Department of Planning and Zoning

TO: Development Review Board
FROM: Scott Gustin
DATE: April 2, 2013
RE: 12-0776CA/MA amendment; 151 St. Paul Street & 101 Main Street

Request: Amend ZP#12-0776CA/MA (139 room hotel and parking garage) for changes to main entryway, fenestration, materials, parking, landscaping, and utilities.

SITE
PLAN

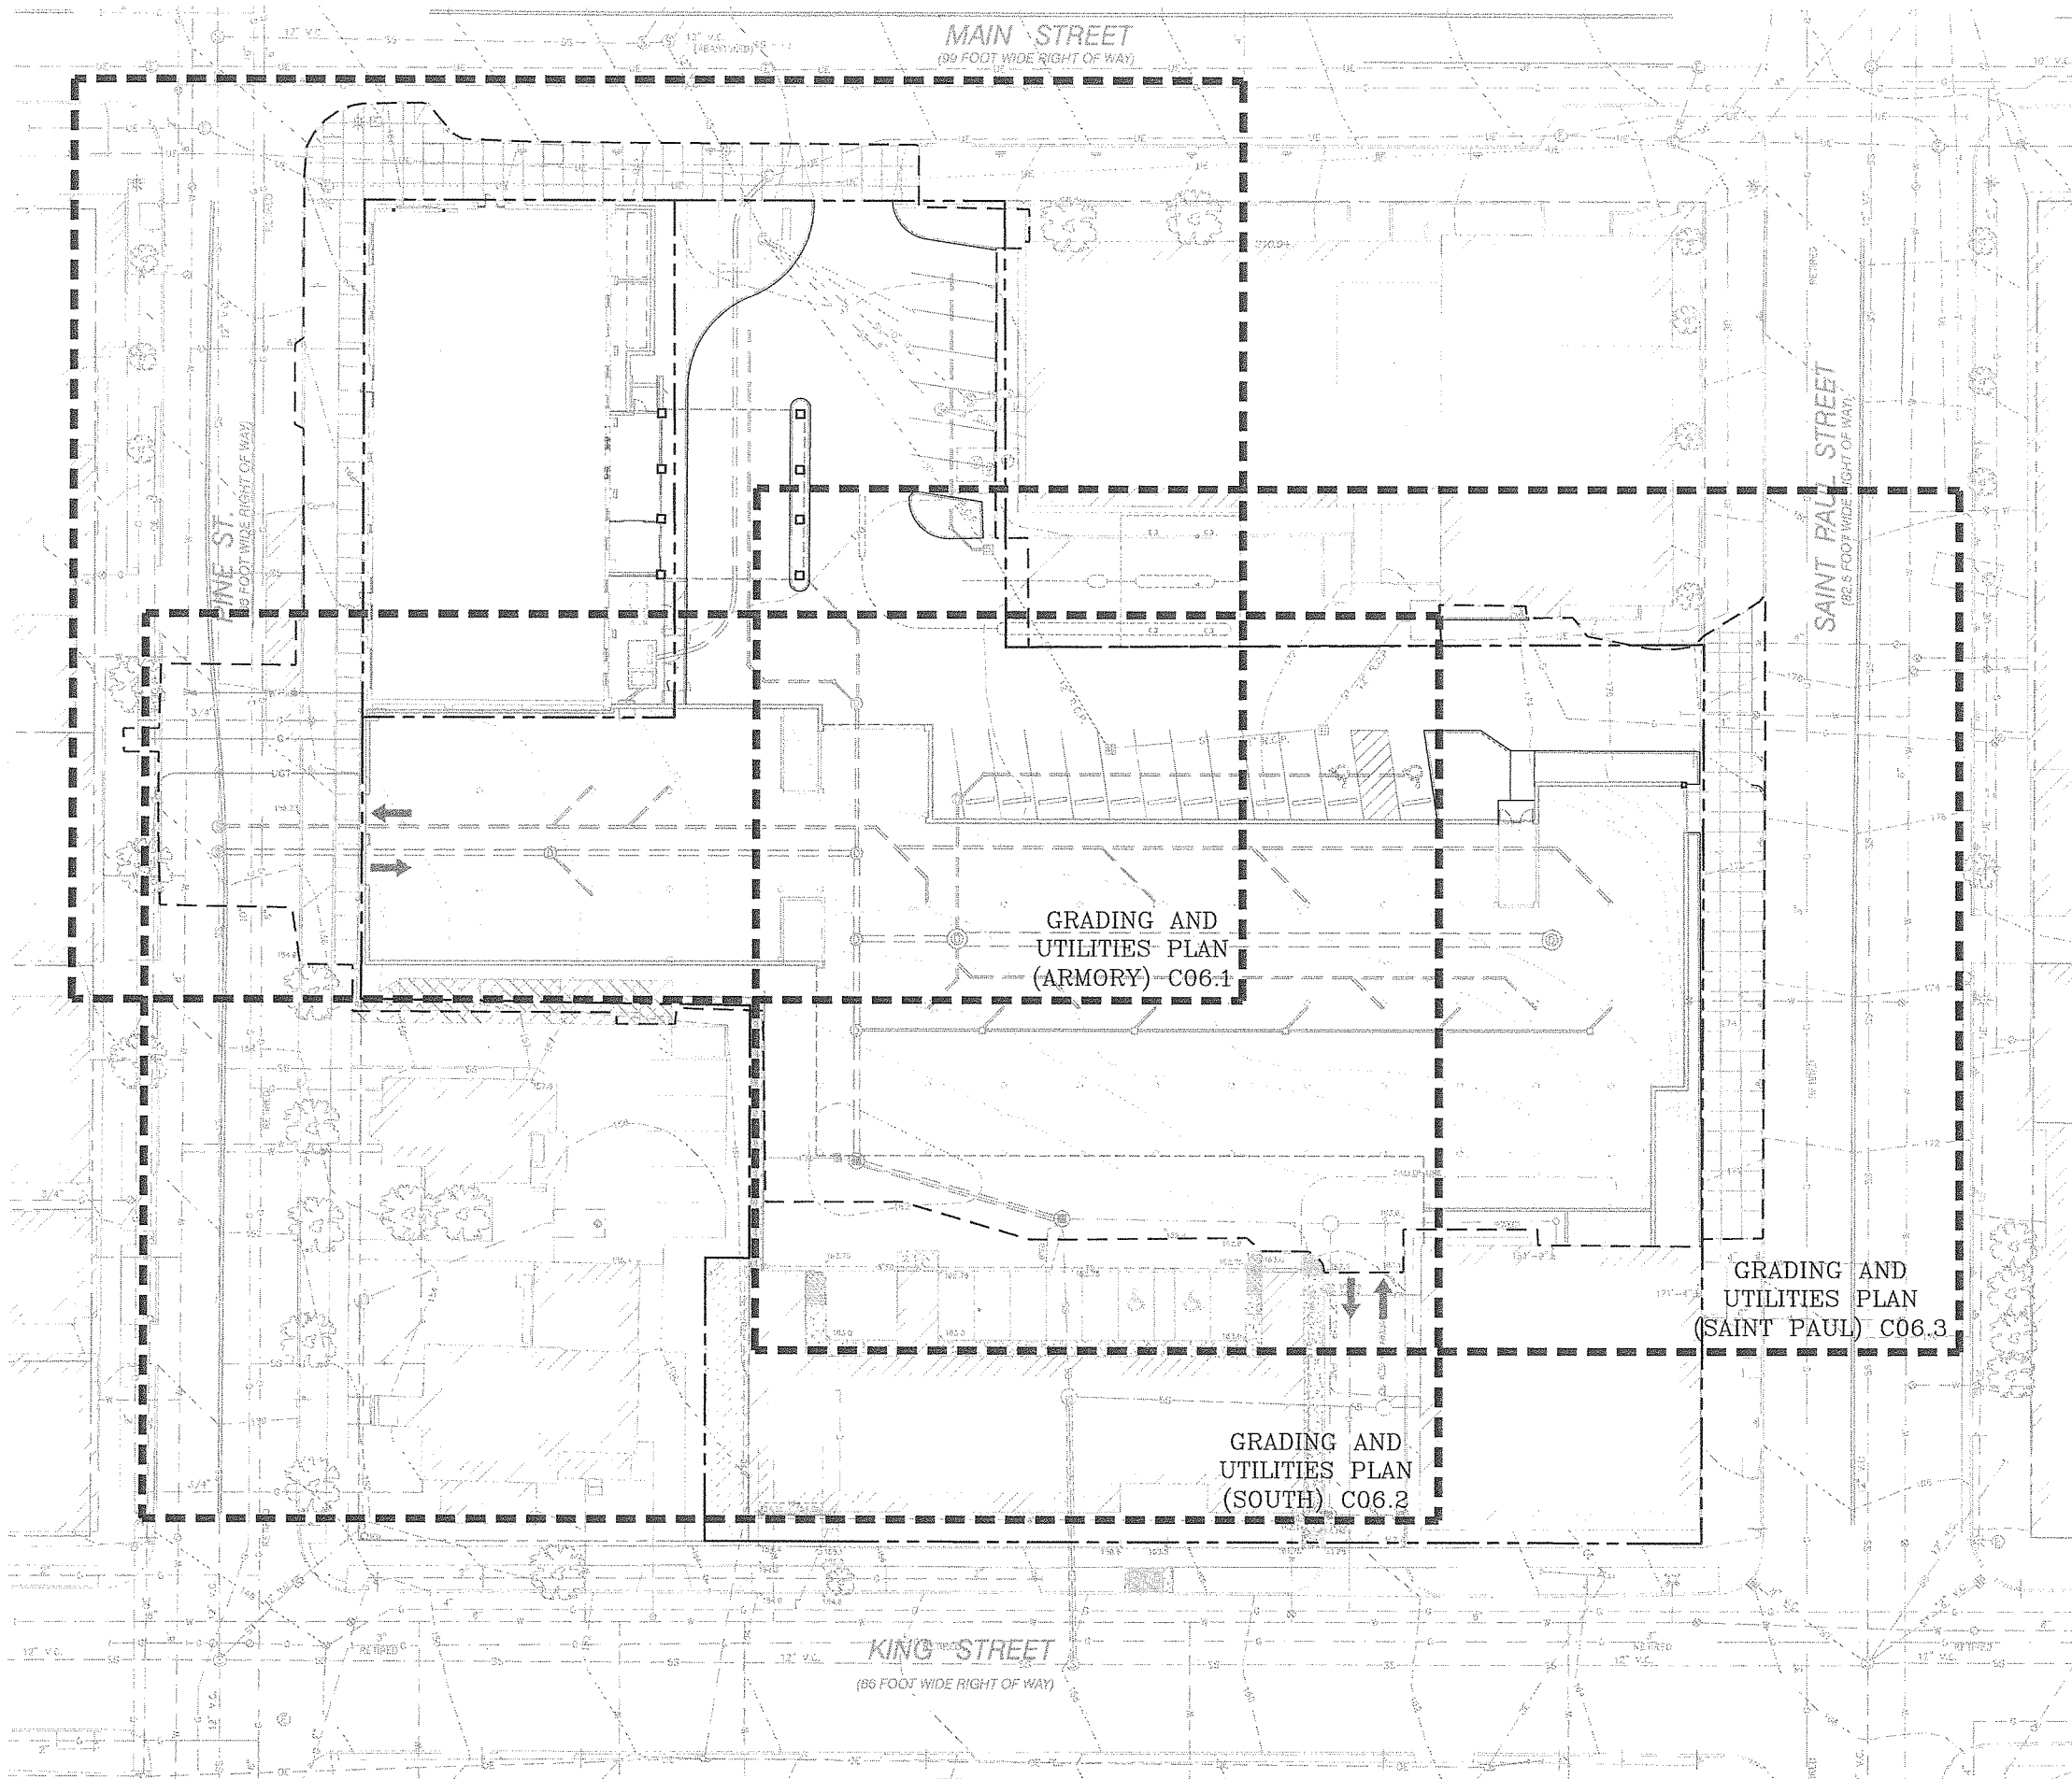
The proposed hotel and parking garage require a total of 11 long term bicycle parking spaces and 14 short term bicycle parking spaces. The amended project plans continue to include acceptable long term bicycle parking spaces. Short term bike parking has been modified to delete racks by the hotel's main entry in favor of 7 "U" racks in within the Main Street right-of-way. The city's Transportation Planner, Bicycle & Pedestrian Program Manager, Environmental Planner has accepted this revision; however, it will require approval by the City Council. The 7 "U" racks will provide spaces for 14 bikes. **(Affirmative finding as conditioned)**

1. Except as specifically modified in this approval, all conditions of the original project approval (zoning permit 12-0776CA/MA dated 6/5/12) shall remain in effect.
2. The “U” bike racks installed within the public right-of-way require review and approval by the Department of Public Works and the City Council prior to installation.
3. Standard permit conditions 1-15.

EXTERIOR BUILDING
ELEVATIONS

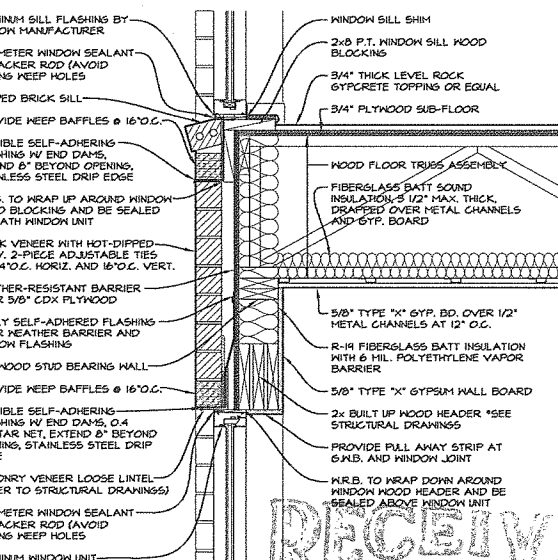
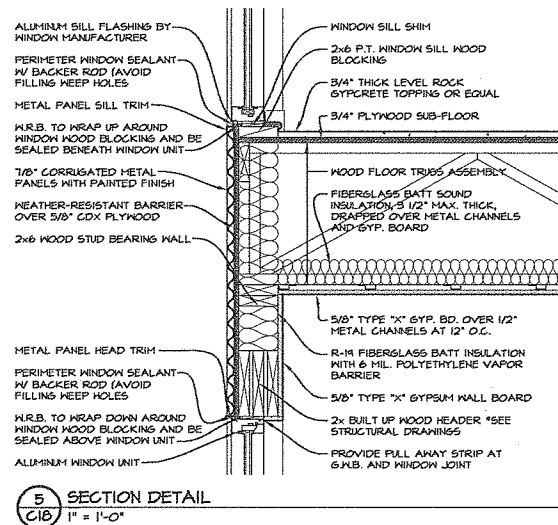
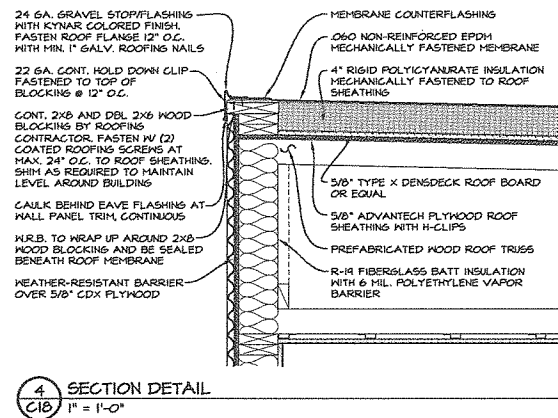
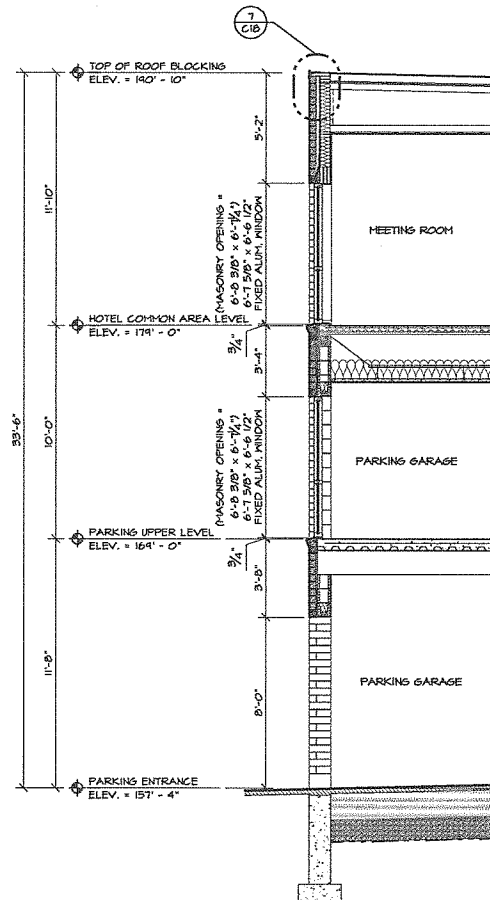
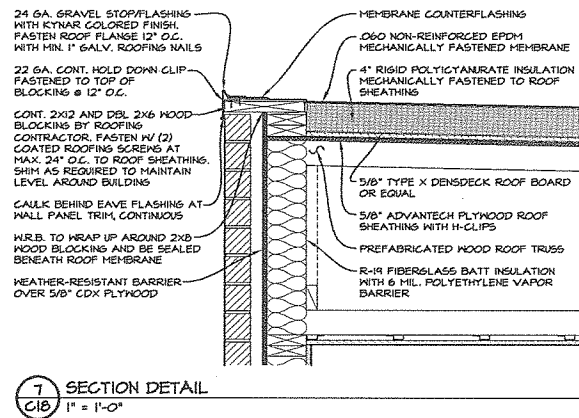
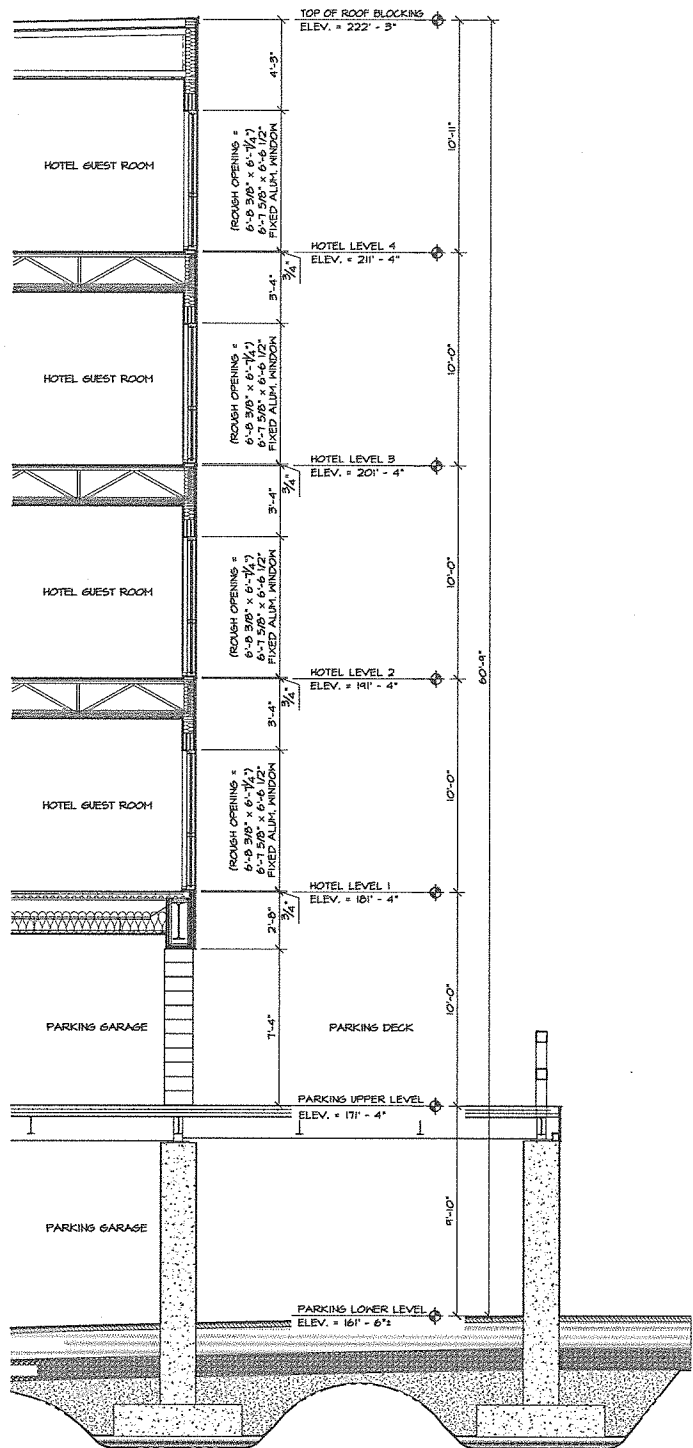
Only slight changes to fenestration are depicted in the most recent project plans. It continues to be appropriately patterned with some diversity and is successfully used to accentuate distinct building elements. **(Affirmative finding)**

The most recent project plans depict the same building materials as originally approved, albeit in slightly different configuration. The materials consist of dark gray brick, corrugated steel panels, and high density timber-faced panels. Metal framed windows are proposed, and roofing will consist of EPDM material. **(Affirmative finding)**

The rooftop mechanical enclosure depicted on the original approval has been changed slightly. It consists of three smaller components and is depicted on the revised elevation drawings.
